REMARKS

Applicant respectfully requests that a second preliminary amendment be made to the above-entitled application. By separate letter to the Official Draftsperson, substitute sheets 1 and 2 of the drawings are enclosed together with marked up copies showing the changes.

Fig. 1 (Prior Art)

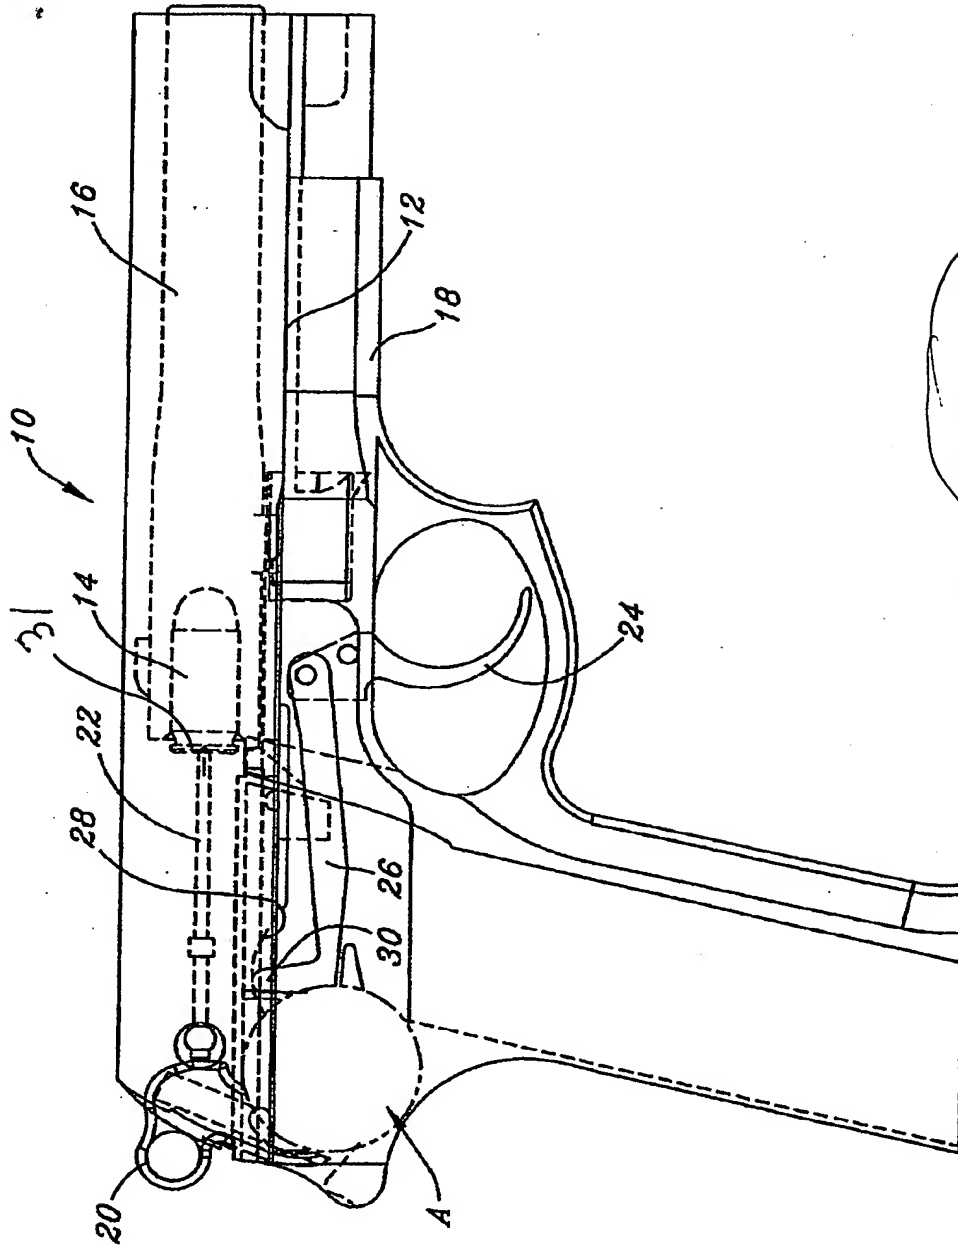
The specification has been amended to clarify the description of Fig. 1 as being prior art having a conventional bolt face 31.

The specification and drawings have also been amended to add missing reference numbers, to further clarify the description, make minor corrections and to properly show the extractor, which was inadvertently omitted or incorrectly depicted in some views, without adding new matter.
